***MODIFICATION REQUEST:***

***Lot 1 DP 702144 & Lot 100 DP 624581  
86-96 and 100 Mount Street, North Sydney***

***MP 08\_0241 MOD 2 – Modification to the approved  
Commercial and Retail Development***

Secretary's Environmental Assessment Report  
Section 75W of the *Environmental Planning and  
Assessment Act 1979*

**Figure 6:** Comparison of the approved and proposed external facades

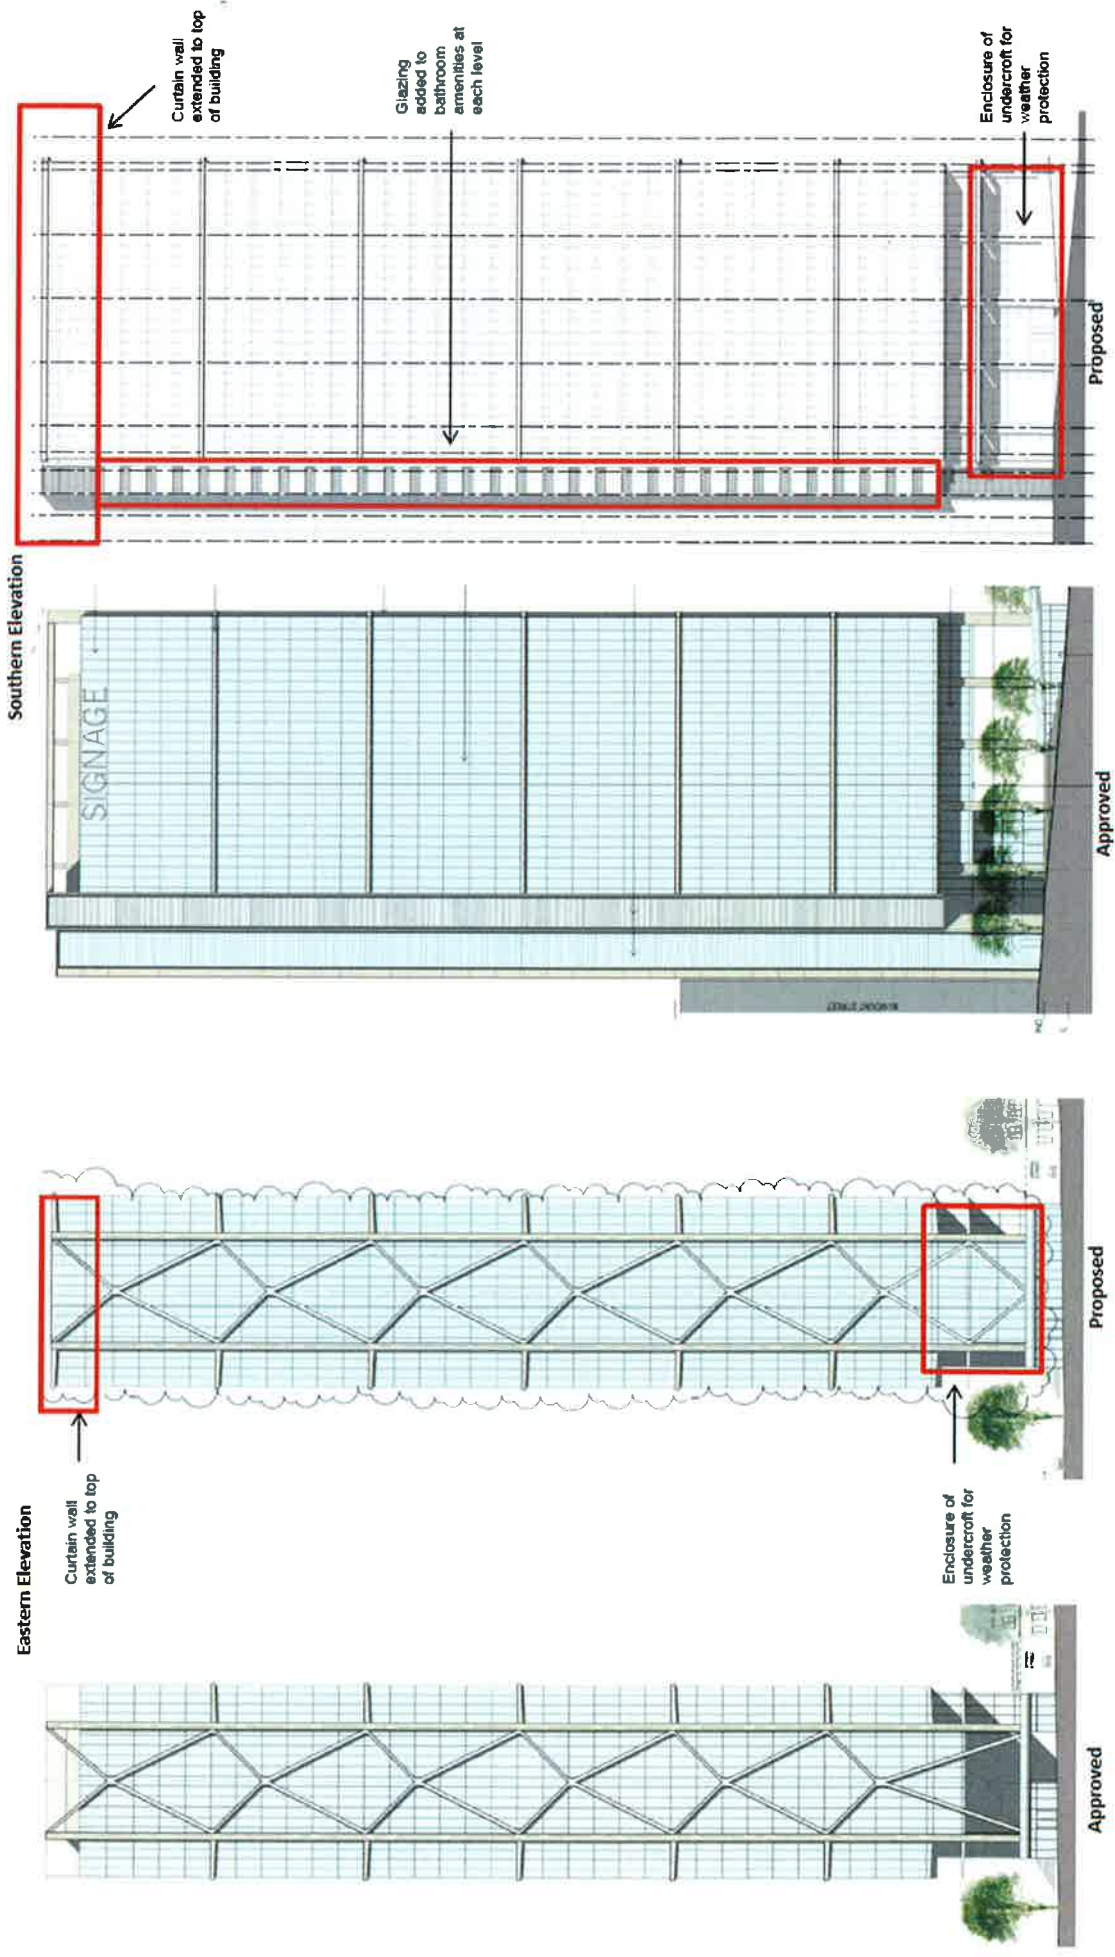
A comparison of the approved building and proposed external changes to the façade is shown in **Figure 6**.

The Department notes the raised roof level from RL 194.7m AHD to 196.7m AHD enables the provision of an additional plant mezzanine level comprised of some plant and mainly void areas. Whilst the roof level is raised the Department notes the maximum building height of the building is reduced by 1.7 metres (from RL 199.7m AHD to RL 198m AHD). The Department is satisfied the minor increase in the height of the roof level and overall mass of the building would not be discernable from the street level. Further the overshadowing impact would be consistent with that approved given the approved development comprised parapet brace blades which provide a similar overshadowing impact as the proposal.

The Department concludes that the proposed external modifications are minor and will provide a refined appearance to the building particularly at the upper level, screening plant from view. The removal of louvres to provide windows for bathrooms, and enclosure of the ground floor lobby with glazing will enhance the amenity of future building occupants.

Overall, the modifications will not result in any discernible increase to the approved height or mass. The Department concludes the proposed external modifications to the façade treatment is generally consistent with the design character of the approved development and is therefore acceptable.

Figure 7: Comparison of approved ground floor (above) and proposed ground floor (below) layout.

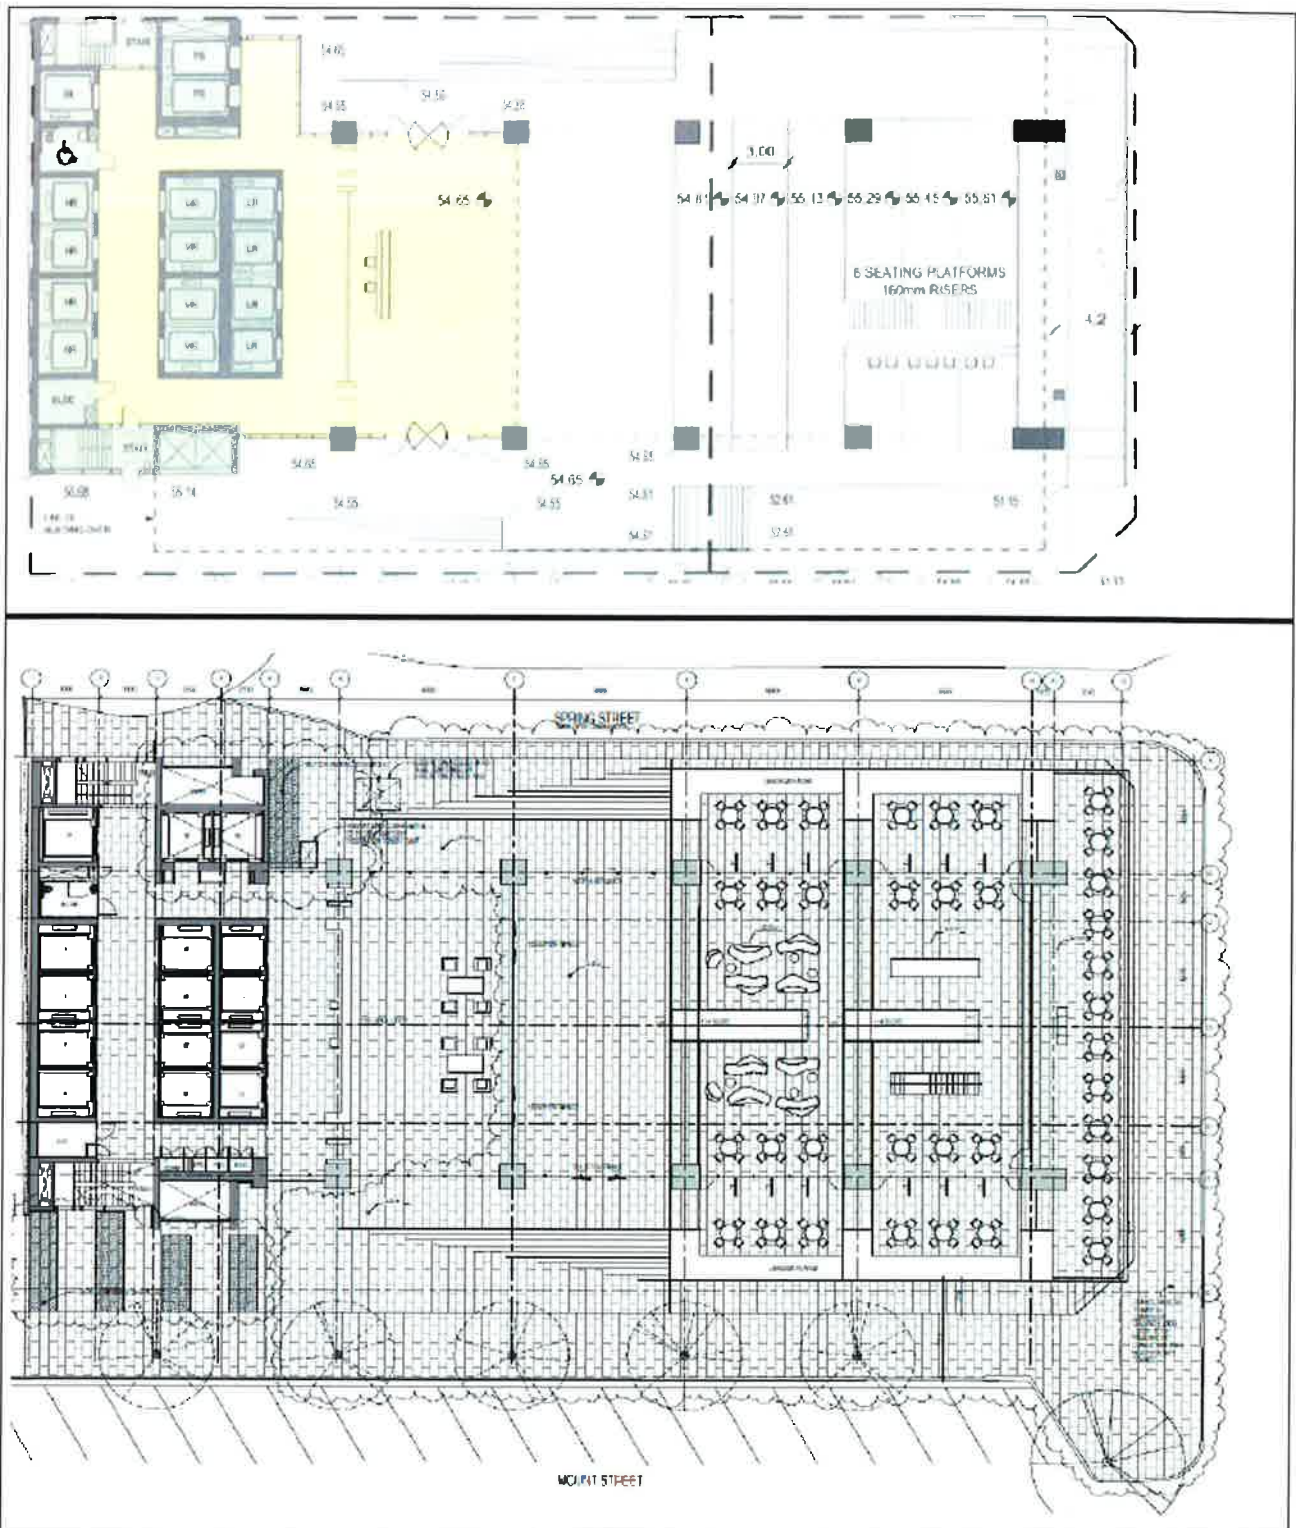
- ground floor level: an open plan lobby area which serves as a through-site pedestrian link during the hours of operation of the building, and a café / restaurant on the eastern side of the building; and
- lower ground floor level: a café / restaurant retail shop on the eastern side of the building with an outdoor seating area, and driveway access to the basement car park levels (**Figure 7**).

- increase in the size of the retail/café area and outdoor seating area;
- enclosure of the ground floor café and through site link with glazing for weather protection;
- granite pavers for the public domain (Walker, Spring and Mount Street pavements) to be discussed and agreed with Council;
- provision of 28 external bicycle spaces in the south western corner of the site, and 10 spaces in the north western corner of the site;
- reduction of street trees at Walker Street from three to two to make allowance for car park driveway cross over to the site; and
- other minor layout changes (**Figure 7**).

The Department concludes that the proposed changes are acceptable. The modifications to the lower ground floor and ground floor levels will improve the overall useability of the ground floor space and public domain. Further, the increase in the retail/café area will further activate the façade, public domain and through site access. The reduction in trees is appropriate given the original approval for three trees did not consider the requirements for a driveway crossover at Walker Street, approved as part of MOD 1.

Council did not raise any objections to the proposed changes but has requested that a condition of approval be provided requiring that the proposed bike parking and final public domain design comply with Council's Public Domain Style Manual (and other relevant standards) and be approved by Council. The Department has recommended an appropriate condition of approval.
